**Courtenay Wind Farm, LLC
200.5 MW Wind Energy Center – Stutsman County
Siting Application**

Case No. PU-13-64

**NOTICE OF INTENT TO CONSIDER ADDITIONAL INFORMATION NOT
PRESENTED AT A HEARING**

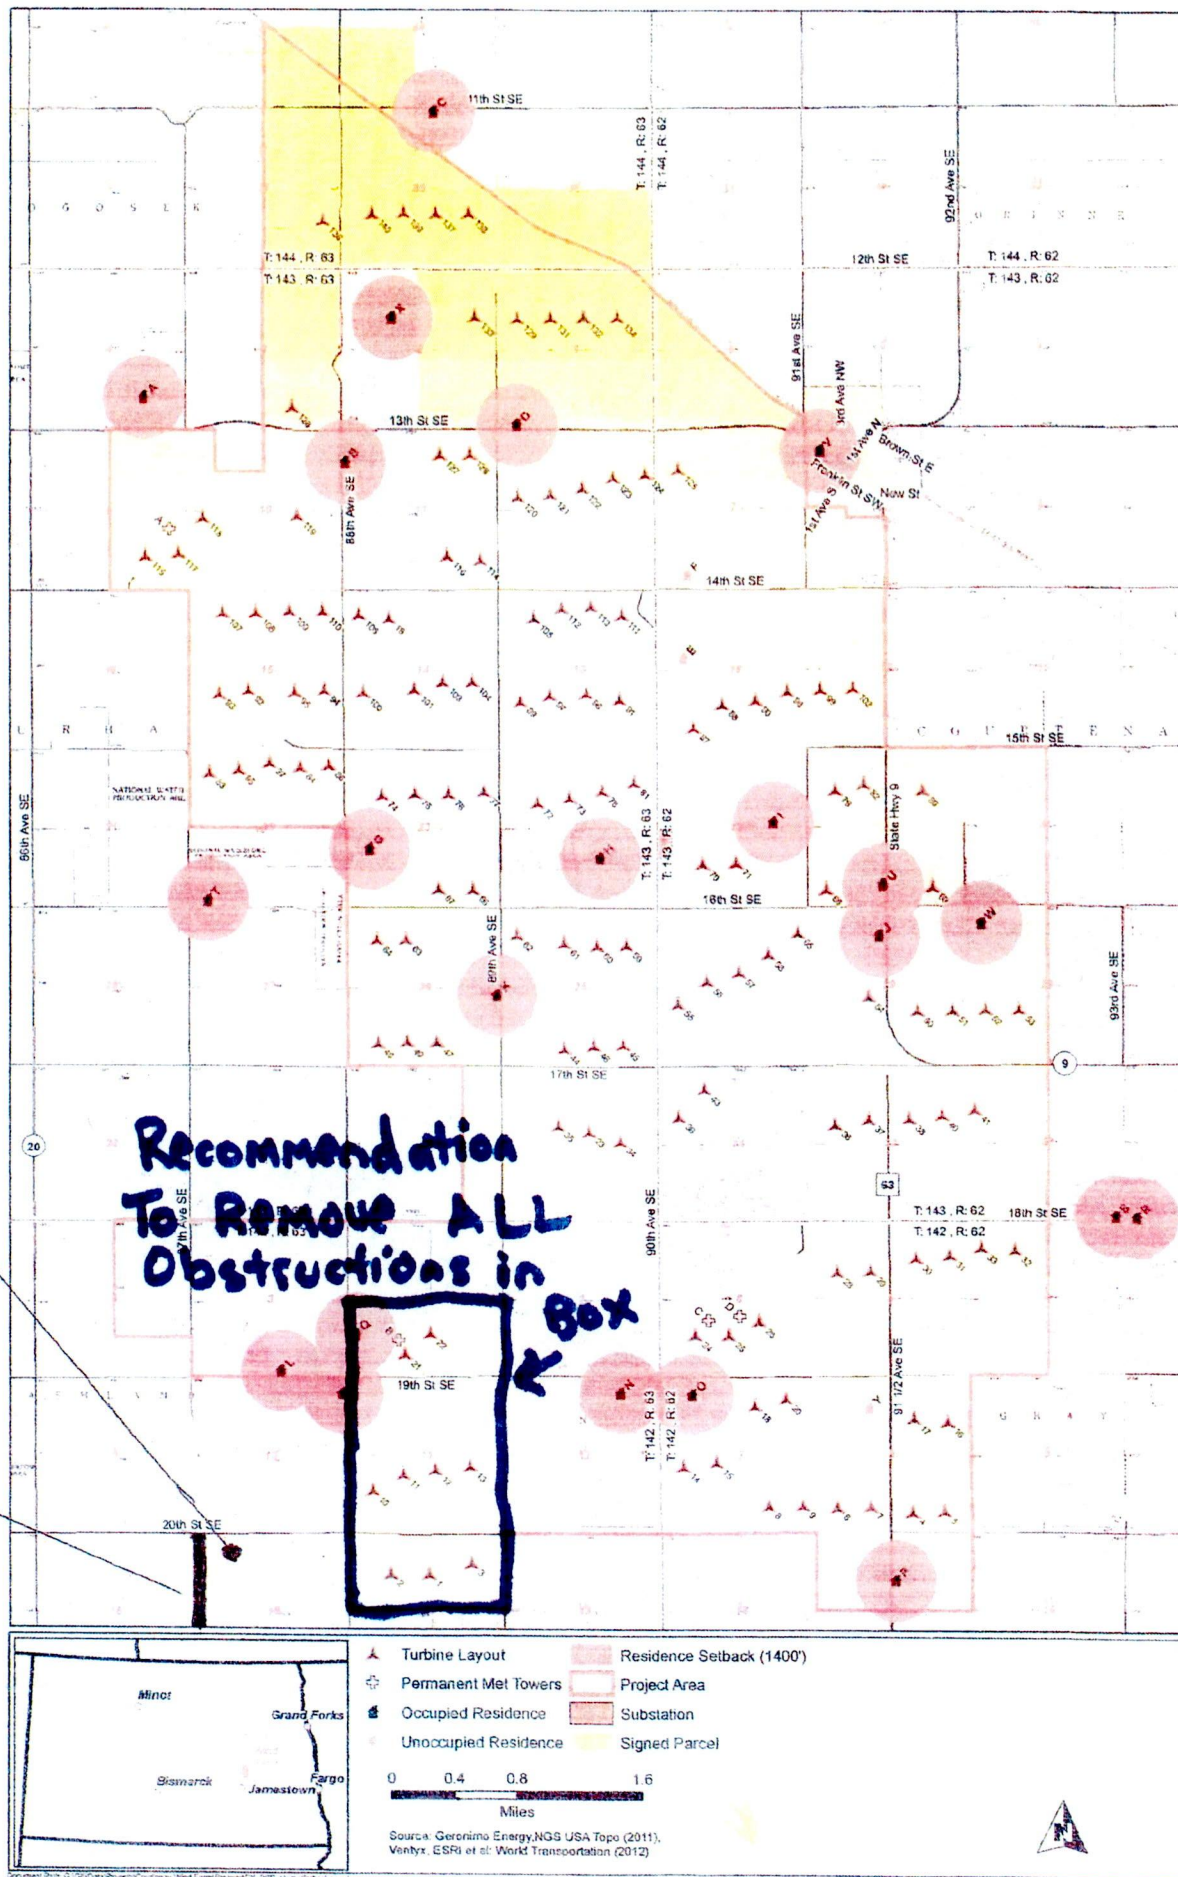
- An object constitutes an obstruction to navigation if the object is 200 ft. above the airport elevation when the obstruction is within 3 miles of an airport. With multiple wind turbines planned to be approximately 500 ft. above the airport elevation, this is a safety concern.
- The proposed wind turbines would also conflict with the FAA Part 77 conical airspace of the airport. This airspace is important for an airport, as it allows the safe transition of aircraft departing and arriving to the airport. (see attached illustration)
- The Sprague Airport is a registered and identifiable airport on the North Dakota sectional chart. The airport may be used by the public who are flying in the area and have an emergency. It is very important to protect any airspace that may be utilized by the public.

With the above listed concerns, it is recommended that the following wind turbines and permanent met towers be removed from the current proposal (see attachment):

- Permanent Met Tower B
- Wind Turbine 1, 2, 3, 10, 11, 12, 13, 21, 22

Residence and Runway Location

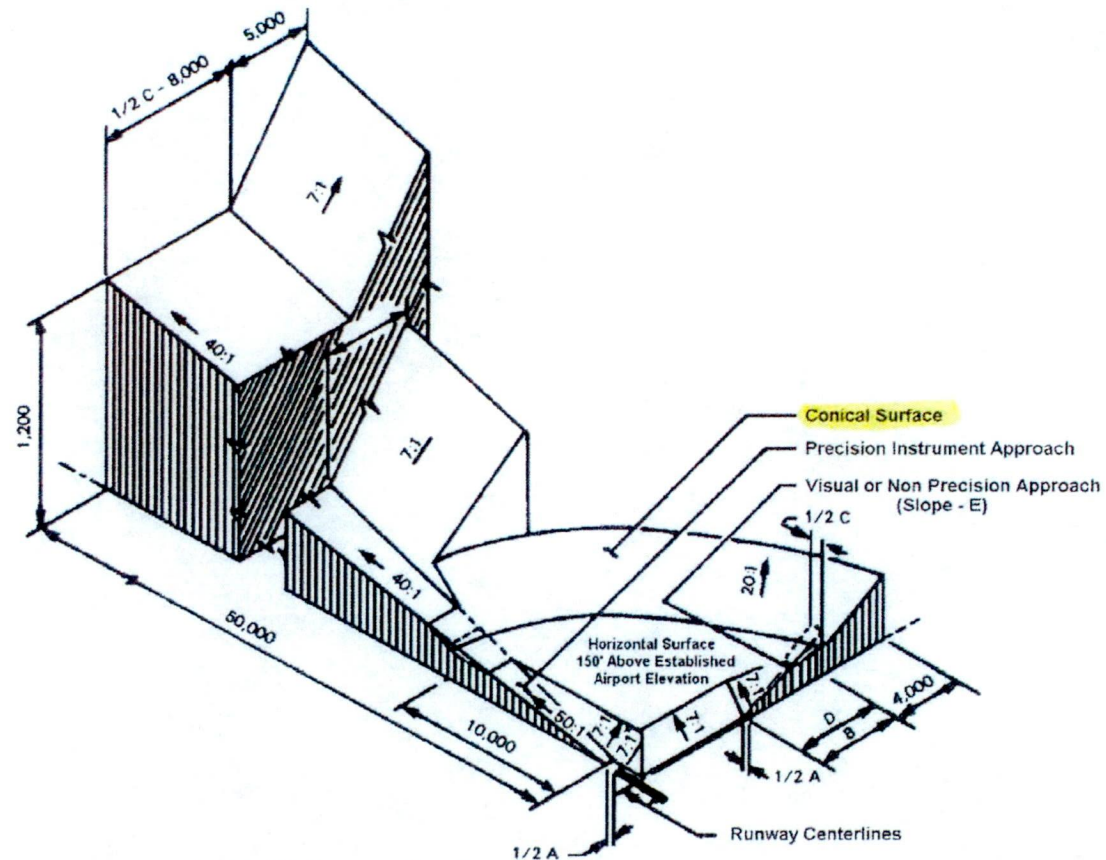
We have attached a copy of Exhibit 4 Part A and marked our residence and runway

location. We have titled it residence and runway location.

We have concerns that turbines 1,2,3,10,11, 12,13,21,22, and permanent Met Tower B will affect the daily operations and safety of landings and take offs of our aerial spraying business runway. All the turbines are within two miles of the runway.

In conclusion, we are not against Courtenay Wind Farm and Geronimo Energy, but **we do ask that turbines 1,2,3,10,11,12,13,21,22, and permanent Met Tower B be moved elsewhere.** We hope this project does not get railroaded through before area residences receive accurate information from Geronimo Energy, on paper, as to where the turbines, and met towers will be located and have a chance to express their concerns.
